TechInfo Sheet

Product Group: Audio	Model: SL-CH9		
Date: 03/11/98	Revision No: 01	Document No: 01	
Subject: Malfunction of Detection Switch

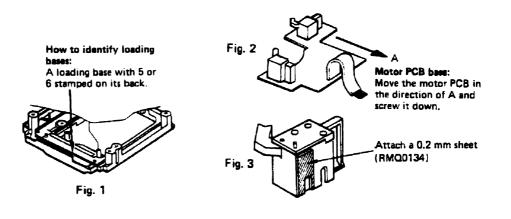
Subject:	Malfunction of tray closure detection switch
Symptom:	When the power switch is turned off after placing a disc in the tray and closing it and turning it on again, the tray will automatically open. (This malfunction tends to be a particularly serious problem when the timer play mode is used).
Cause:	Because the clearance of the loading base is uneven, the thrust of the close detection switch (S101) by the rack gear is insufficient when the tray is closed. This causes the switch to turn off after is has been turned on (the closure is detected). This problem tends to occur when the loading base that has a 5 of 6 stamped on its back, as shown in Fig. 1.

When installing the motor PCB, as shown in Fig. 2, move it in the direction of A and screw it down. Or attach a 0.2 mm sheet (RMQ0134) to the oblique-line portion of the tray switch (see Fig. 3).
